11 June 2013

Moolarben Coal Project Stage 2 – Water Licensing – Wollar Creek Water Source

Subject: ER20296 Independent Reviewer's response to NOW submission for the Moolarben Coal Mine Stage 2 EIS.

Figure 2 – Hydraulic Conductivity Zones as Modelled in PPR Groundwater Assessment

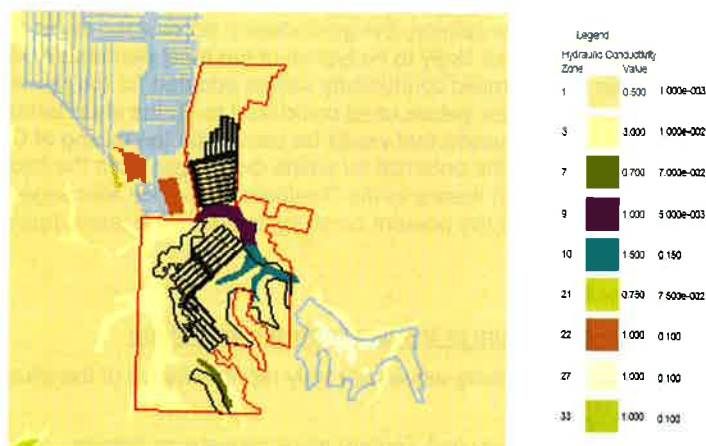
John Williams in his memo indicated that in his opinion, the groundwater bores used to determine the hydraulic properties of the alluvium were not likely to be typical of the most permeable parts of the alluvium. He questioned whether the hydraulic conductivity values adopted for the groundwater model were appropriate, and suggested that the values used could lead to (in the short term) an under-estimate of the amount of baseflow reduction that would be caused by the mining of OC4, and (in the longer term) an under-estimate of the potential for saline discharges from the backfilled mine area to the Wilpinjong Creek system, and thence to the Goulburn River. He also suggested that the connectivity between the alluvium and the present creek system is being under-represented by the groundwater model.

Alluvium Zone (refer Figure 2)	Hydraulic Conductivity Values Used in Modelling (m/d)				Comment
	Stage 2 EA		PPR		
	Kh	Kv	Kh	Kv	
Quaternary alluvium	3.0	0.1	3.0	0.1	Limited development – shallow depth localised occurrence. Distribution defined from published geological map.
Tertiary paleochannel alluvium – Moolarben Creek (east of OC3)	0.7	0.07	0.7	0.07	Limited presence. Distribution determined from coal exploration drilling.
Tertiary paleochannel alluvium – region between UG4 and upstream of OC4	1.0	0.005	1.0	0.005	Trunk paleochannel – distribution defined from coal exploration drilling and limited groundwater monitoring bores and test bore.
Tertiary paleochannel alluvium – Murragamba and Eastern Creek valleys, and Wilpinjong Creek valley adjacent to OC4	0.4	0.005	1.5 [†]	0.15	Trunk and tributary paleochannels – distribution defined from coal exploration drilling and groundwater monitoring bores.

The distribution of the above alluvium zones in the PPR modelling is shown on the attached **Figure 2**.

Figure 3 – Hydraulic Conductivity Zones for Paleochannel Hydraulic Conductivity – Scenarios 1 and 2

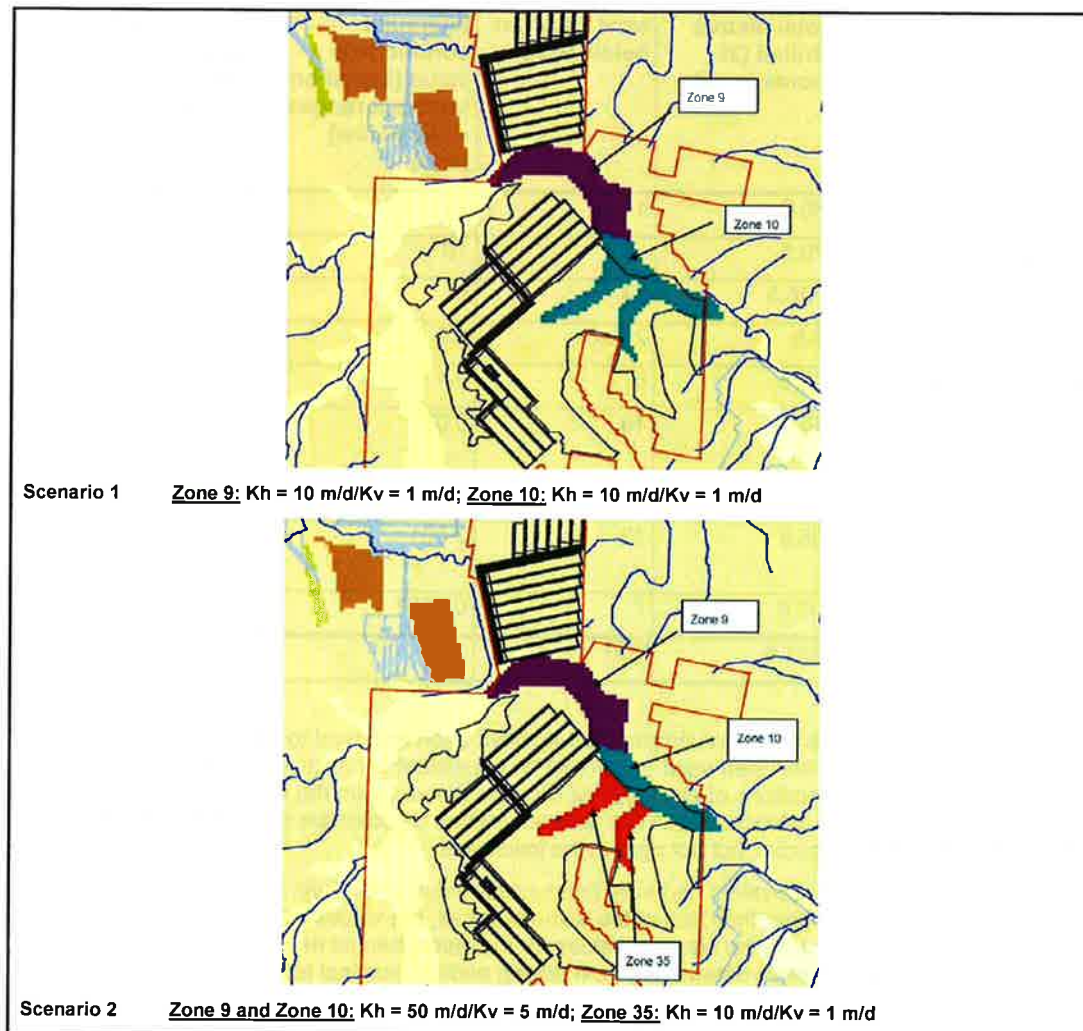
- Scenario 1 – Paleochannel hydraulic conductivity increased to $K_h = 10 \text{ m/d}$ and $K_v = 1 \text{ m/d}$
- Scenario 2 – Trunk paleochannel hydraulic conductivity increased to $K_h = 50 \text{ m/d}$ and $K_v = 5 \text{ m/d}$; tributary paleochannel conductivity increased to $K_h = 10 \text{ m/d}$ and $K_v = 1 \text{ m/d}$.

The distribution of K_h and K_v values for the two scenarios are shown on **Figure 3**.

Figure 4 - Predicted Total Groundwater Inflows to OC4 (Alluvium + Permian)

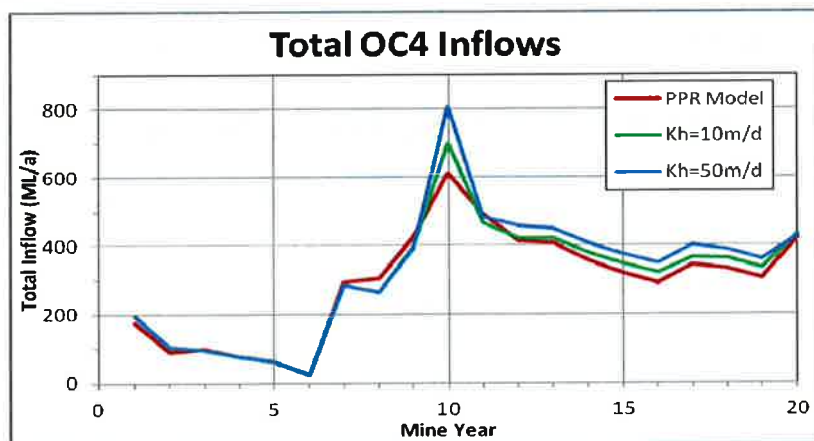
In the two additional scenarios modelled, total pit inflows to OC4 are predicted to increase slightly above those predicted in the PPR modelling, as illustrated on **Figure 4**.

The peak inflow, which occurs in Year 10, is predicted to be up to 14% higher (for $K_h = 10 \text{ m/d}$) or 31% higher (for $K_h = 50 \text{ m/d}$) than predicted in the modelling for the PPR. The inflows shown on **Figure 5** are total inflows, ie from both alluvium and Permian, however as the only changes from the PPR model are the changed hydraulic conductivity values in the paleochannel alluvium, it is reasonable to assume that the majority of the increase in total inflows will be inflows from the paleochannel alluvium.

Figure 6 – Predicted Baseflow Reduction Due to Stage 2 - Reaches R107, R108 and R109A

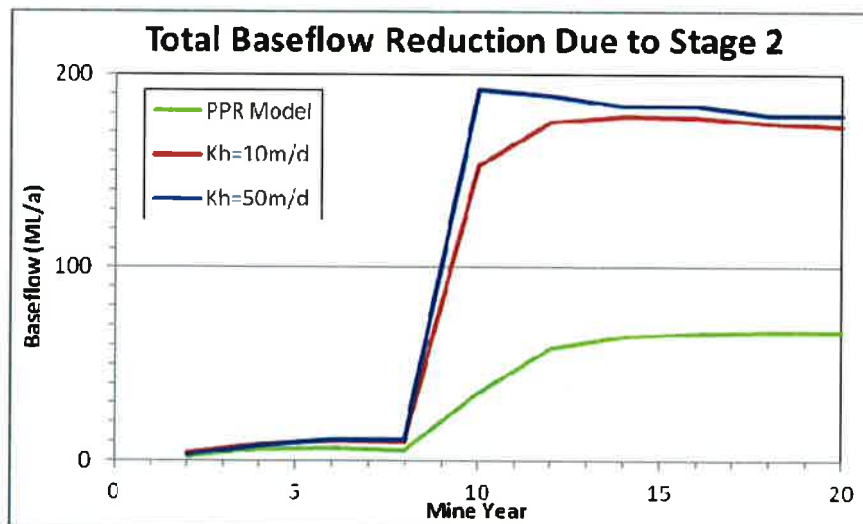
Figure 6 shows comparative baseflow reductions due to Moolarben Stage 2 in the above three reaches combined. It is seen that maximum baseflow reduction is predicted to be 178 ML/a for the $K_h = 10\text{m/d}$ case, compared with maximum baseflow reduction of 67.1 ML/d in the PPR modelling. For a K_h of 50m/d, the maximum baseflow reduction is predicted to be 191.8 ML/a, compared with 67.1 ML/a for the PPR modelling.

However, the predicted impacts due to Stage 2 (ie the incremental increase in impact between the “all projects” model and the “no Stage 2” model) have been determined with models that are uncalibrated, the implications of which are discussed further below. Hence the impacts predicted must be considered with caution. The unreliability of these predicted impacts is perhaps best illustrated by consideration of the total pre-Stage 2 baseflows predicted by the two high permeability model scenarios, compared with actual observed stream flows.

Figure 7 - Monitored Streamflow vs Predicted Baseflows - Gauge MOOLC003 (Wilpinjong Creek)

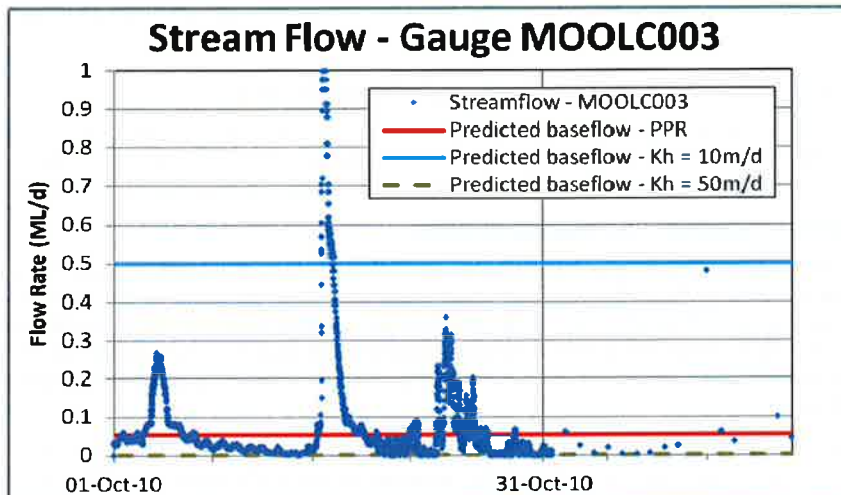
Total baseflows predicted by the two new scenarios are found to be unrealistically high, as illustrated by Figure 7. This graph shows a comparison of the actual streamflows monitored at Wilpinjong Coal Mine’s gauging station MOOLC003 on Wilpinjong Creek, just upstream of the Murrumbidgee Creek confluence, during an early part of the streamflow record (October-November 2010), with the pre-mining baseflows predicted for reach R108 in the PPR and the two new modelling scenarios. All are converted into units of ML/d.

The PPR model predicted a pre-Stage 2 baseflow of 20.5 ML/a, or 0.056 ML/d, for Reach R108, whereas the $K_h = 10\text{m/d}$ scenario model predicted a pre-Stage 2 baseflow of 180 ML/a, or 0.5 ML/d. The $K_h = 10\text{m/d}$ baseflow is not consistent with the actual streamflows monitored at the gauge, whereas the PPR model baseflow is.
